## **TILLMAN'S CORNER SOUTH SUBDIVISION**

APPLICATION NUMBER 4 DATE April 20, 2017

REQUEST Subdivision

# DETAIL SITE PLAN

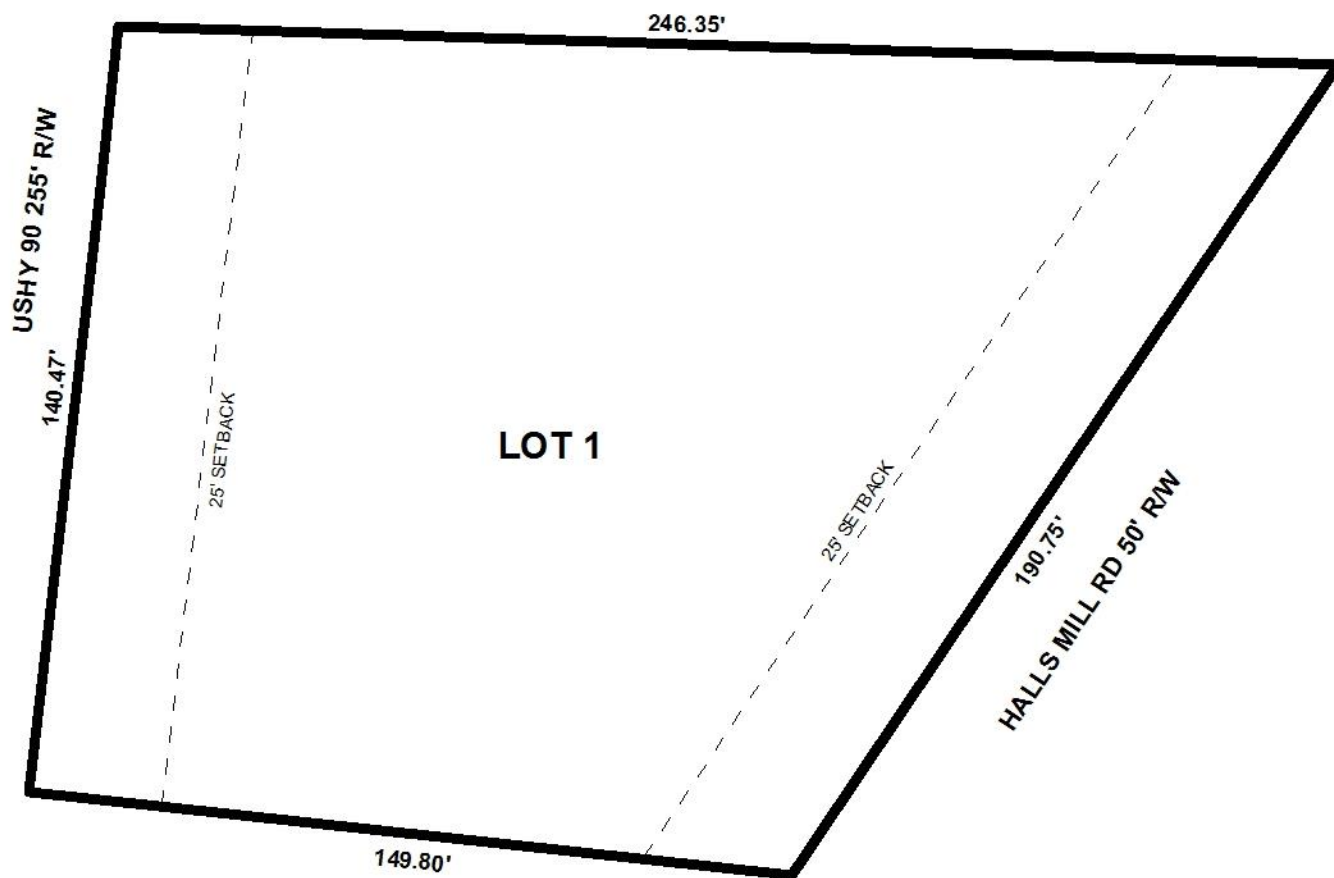
The previously approved subdivision required dedication to provide 35' from the centerline of Halls Mill Road, and the applicant is trying to have this condition removed due to the proximity of a proposed gas canopy and dumpster, both of which would be located within the 25' setback if dedication is required. The Planning Commission has previously required this same dedication for recent subdivisions within 400'± of the site. It should be noted that while the Major Street Plan is in the process of being reconfigured, the required right-of-way along this segment of Halls Mill Road is proposed to remain the same. Furthermore, adjacent properties are metes-and-bounds parcels, and would be required to provide the same dedication in the event of a subdivision application, therefore waiving the requirement for dedication at this location would set a precedent in the area.

The site has frontage along U.S. Highway 90 West and Halls Mill Road. U.S. Highway 90 West is an ALDOT controlled right-of-way and is a major street on the Major Street Plan, and as such requires a 250' right-of-way. The preliminary plat illustrates an existing right-of-way of 255', thus no dedication is required. Halls Mill Road is a collector street in this area, and as such should have a 70' right-of-way. The preliminary plat illustrates an existing 50' wide right-of-way, making dedication to provide 35' from the centerline necessary.

It should be noted that the site has an existing shared curb cut to the existing oil change business to the South, however, as the shared access is in the right-of-way, and not on private property, it was determined that a Planned Unit Development was not required. As a means of access management, the lot should be limited to the existing shared curb cut along U.S. Highway 90 West and two curb cuts to Halls Mill Road, with size, location and design to be approved by ALDOT where necessary as well as Traffic Engineering and conform to AASHTO standards.

The preliminary plat does illustrate the 25' minimum building setback along both frontages. If approved, this information should be retained on the Final Plat as well.

The preliminary plat as submitted contains the survey of the property on one sheet, with a second page containing notes and signature blocks. If approved, the Final Plat should have all pertinent information on one page.

- 1) provision of survey and all necessary notes and signature blocks on a single page;
- 2) dedication to provide 35' from the centerline of Halls Mill Road;

- 3) provision of the lot size in square feet and acres, adjusted for dedication;
- 4) retention of the 25' minimum building setback line along both frontages;

- 5) placement of a note on the site plan stating that the lot is limited to one curb cut to U.S. Highway 90 West and two curb cuts to Halls Mill Road, with size, location and design to be approved by ALDOT where necessary as well as Traffic Engineering and conform to AASHTO standards;
